# SERVICE - INFO

**DEUTZ\*\* – 228 0007 16 – 280/280 TGU6**

TBI\_sdf228000716

**New design / Neues design / Nouvelle conception / Nuevo dissent / Nuevo diseno**

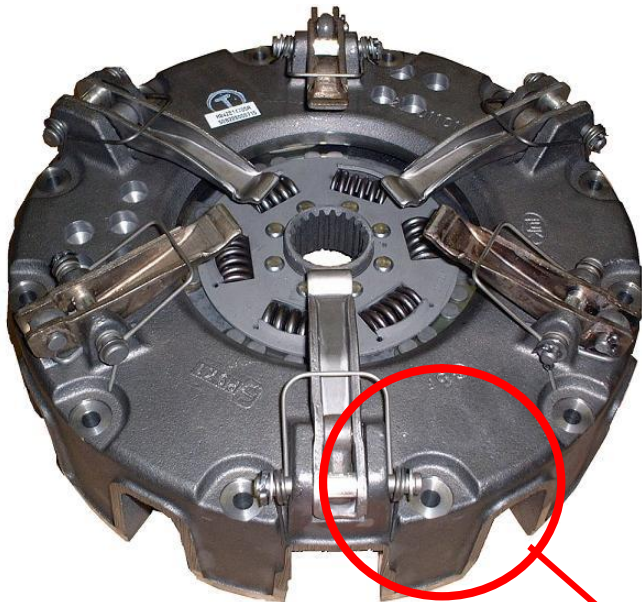
The new design utilises the latest clutch technology using a vented housing for improved cooling and heat dispersal.

**Fully interchangeable with existing clutches with no modifications required to vehicle or flywheel.  
New fixation bolt set 6 x M8 x 1.25 x 45mm is supplied with new designs to accommodate the lower housing.**
